Option to bypass error marking

(supporting comment #205)

IEEE P802.3bj 100 Gb/s Backplane and Copper Cable

January 2013, Phoenix

Analysis of correction without marking (mode C)

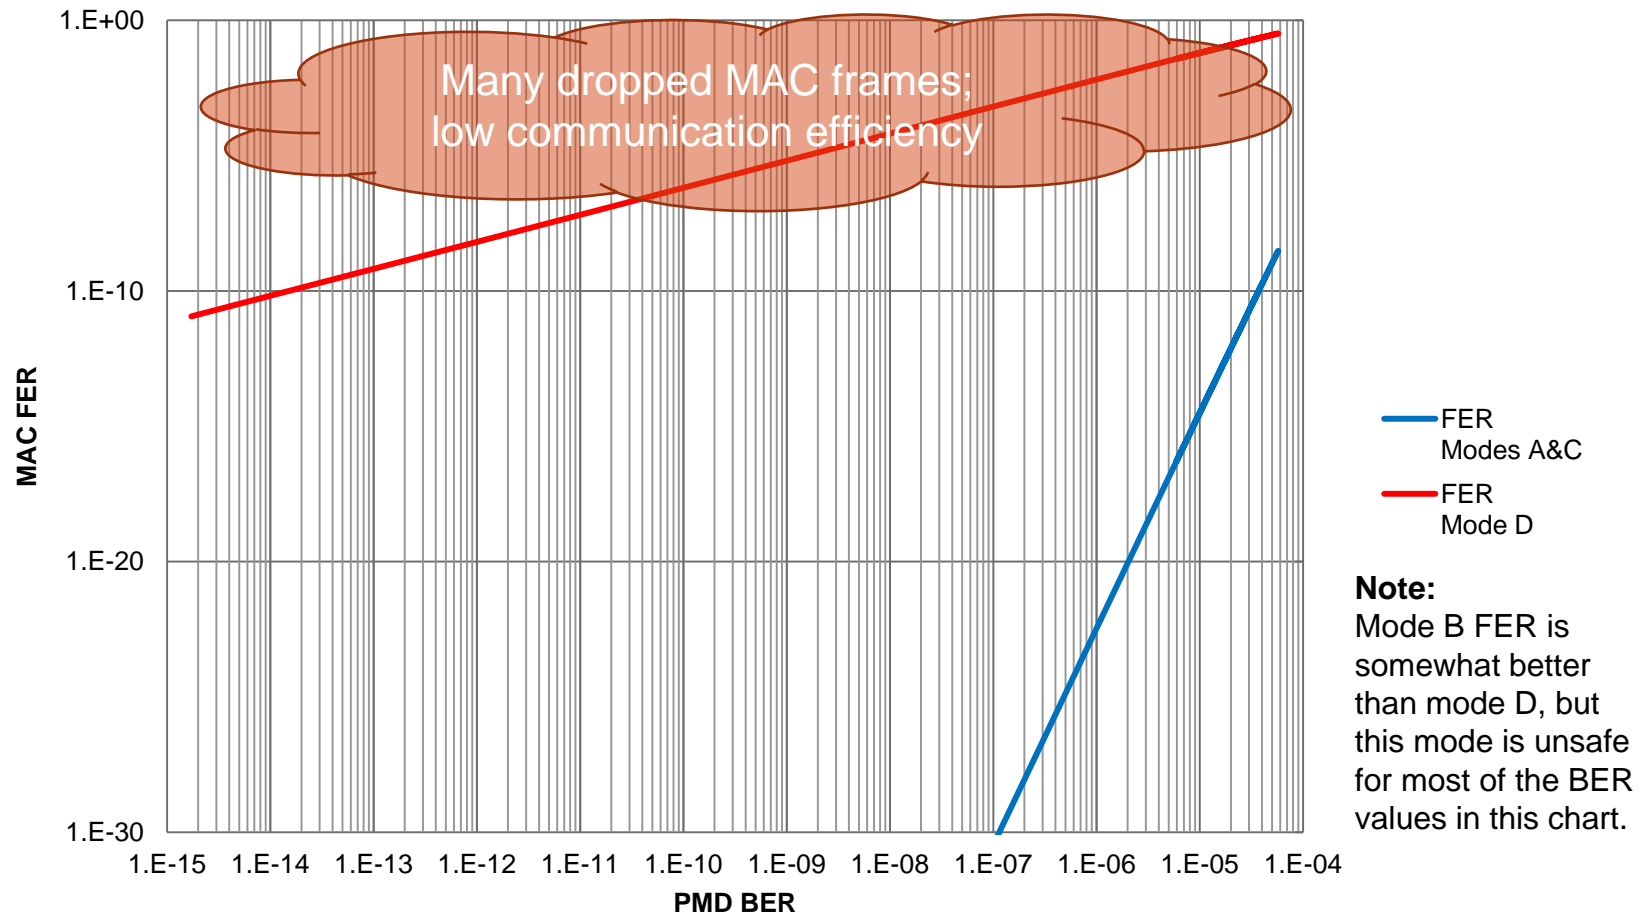
- With PMD BER of $4e-5$, FER target of $1.7e-10$ is obtained, but MTTFPA $\approx 5K$ years
- However, to improve MTTFPA 10-fold, PMD BER should only be improved slightly, to $\sim 3e-5$
 - This relates to ~ 0.15 dB SNR improvement (AWGN assumption)
 - Each additional 0.15 dB improves x10
- Improving PMD BER to $6.1e-6$ brings MTTFPA to $\sim AOU$ (13G years)
 - This requires only ~ 0.89 dB SNR improvement
 - Also creates a virtually error-free link (FER $< 1e-16$)

Calculations assume CR4/KR4 RS-FEC, with highly correlated errors (DFE C=1).
Using C=0.1 results in $\sim 2x$ higher MTTFPA .

MTTFPA and MTTD vs. PMD BER

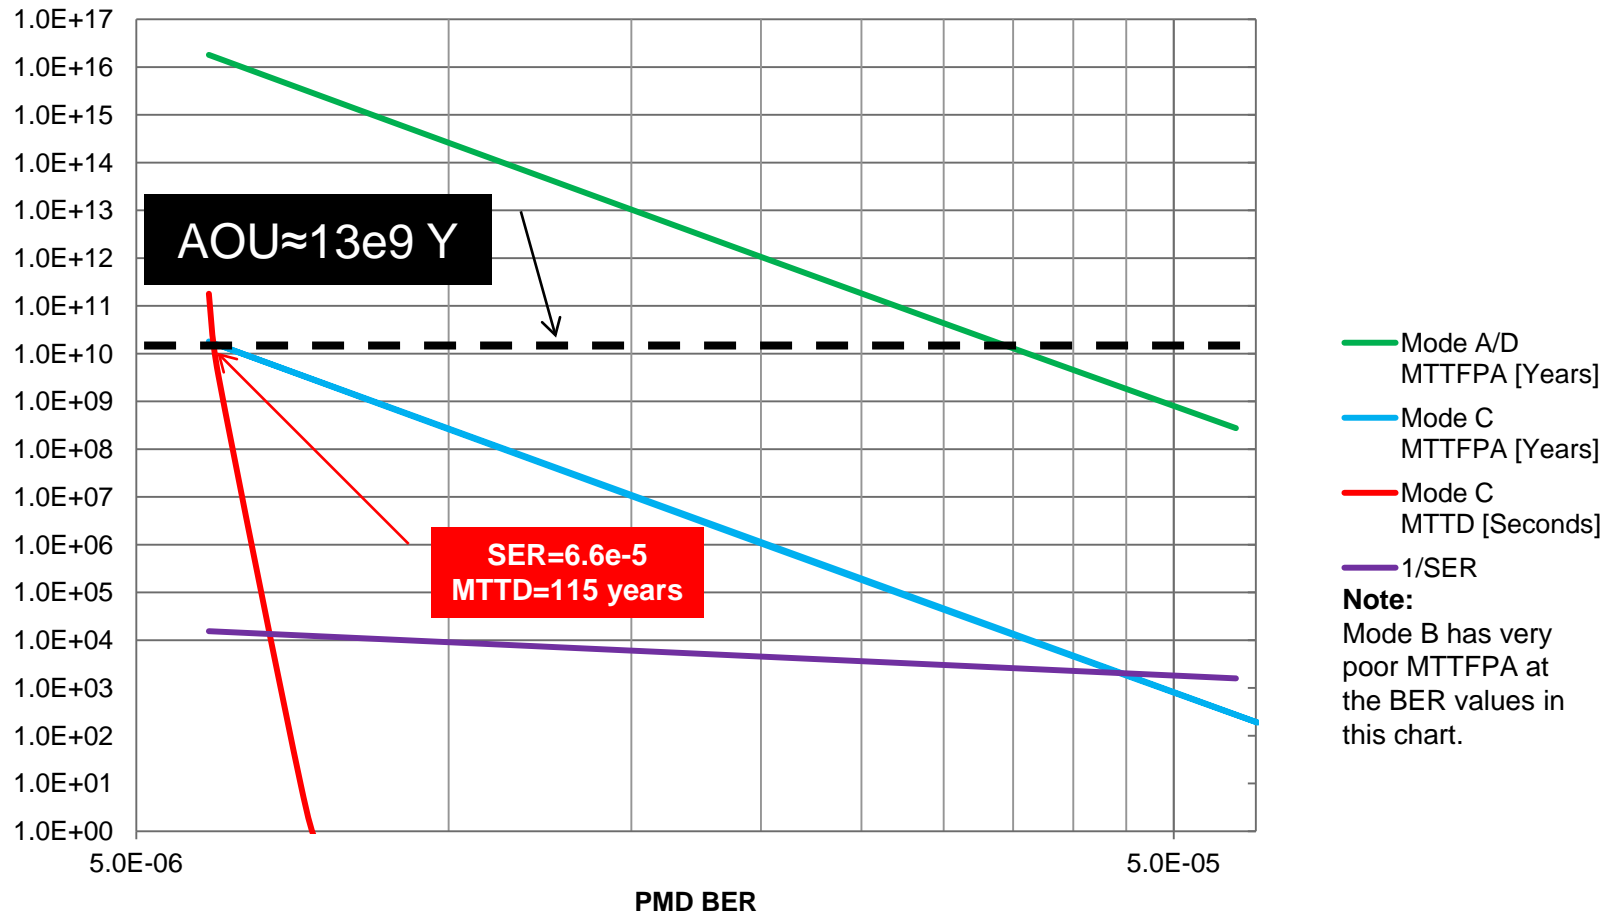
Note:
Mode B has very poor MTTFPA at the BER values in this chart.
